**VALUE ENGINEERING CHANGE PROPOSAL
MISSOURI DEPARTMENT OF TRANSPORTATION**

Contract ID 090522-623 Job No. J6I2189

VECP# 10-22 (to be completed by C.O.) VECP ☒ or PDVECP ☐

The current drawing for Bridge A01393 and A01414 call for the wing walls of the bridge to be removed and replaced. The old wall is 12" thick and it is being replaced with 12" of new concrete. In lieu of removing and replacing the backwall, we are offering to leave the existing wall in place and form and pour the new wall in front of the existing wall. The new wall will end at the end of the existing beam seat and will tie in to the existing elevation of the top of the wall as shown on the plans. The top of the wall will be sloped down towards the bridge and will match elevation "F" shown in the plans.

NE Option 2

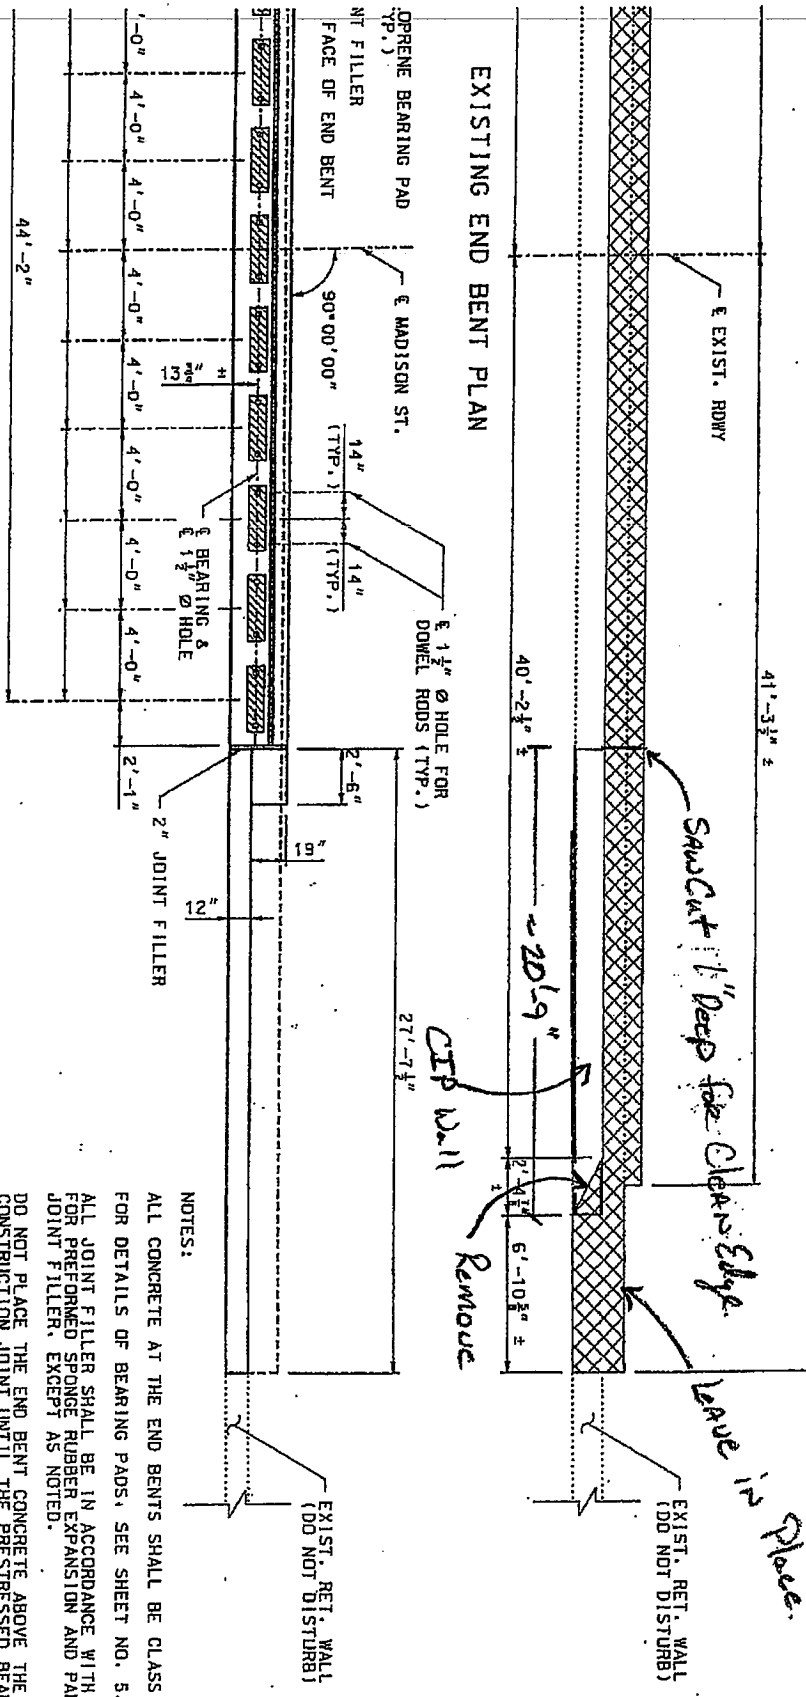
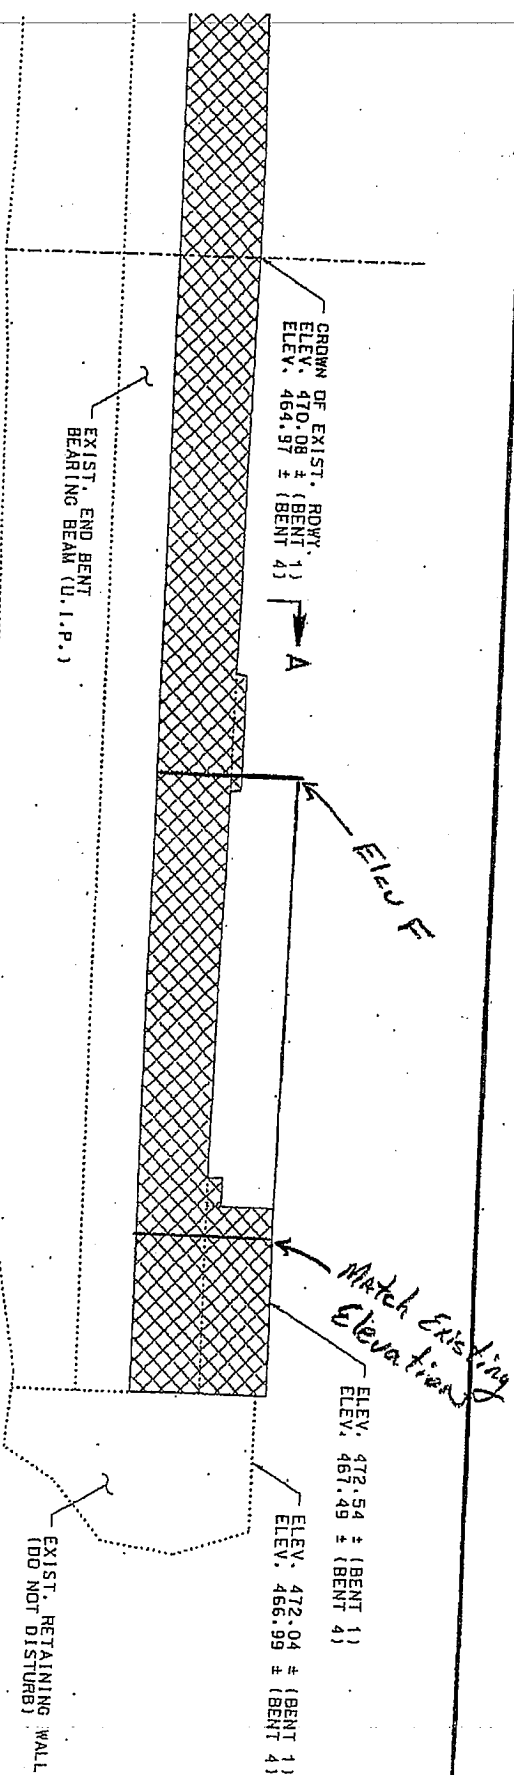
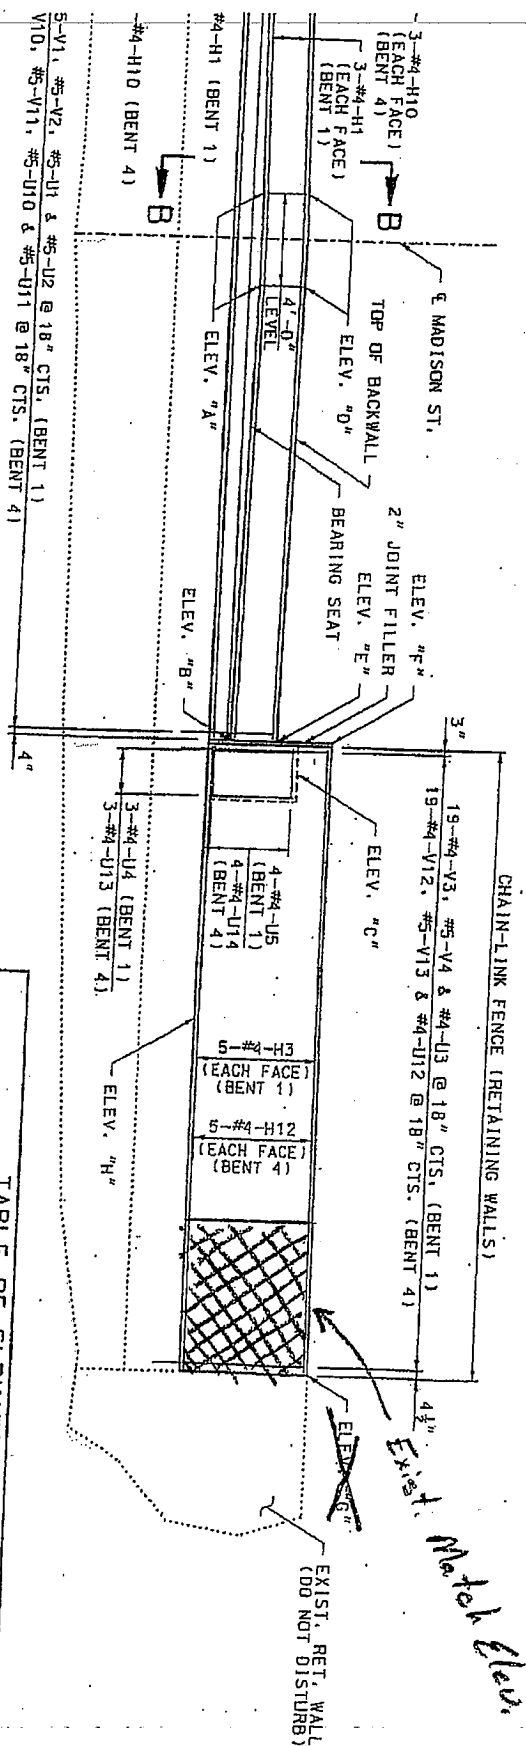
We have a couple concerns with option 1: The existing beam seat will remain exposed and the 6 inch step at the top of the existing retaining wall and the existing backwall will also remain. The exposed beam seat will probably become a maintenance issue? Aesthetics may need to be considered here. The fence alignment will be altered also.

Option 2 addresses the fence/wall alignment and fills the existing beam seat area outside of the proposed bridge. Option 2 probably provides a cleaner appearance over option 1. Let me know if you have any questions.

Option 2 is to leave the existing backwall and fill the void with concrete and extend it up to match the existing wall and elevation F on the bridge side. I estimate there will be approx \$15,000 dollars in savings for this method.

Looks like we could entertain Option 2. Let us know how you would like to proceed. Thanks.
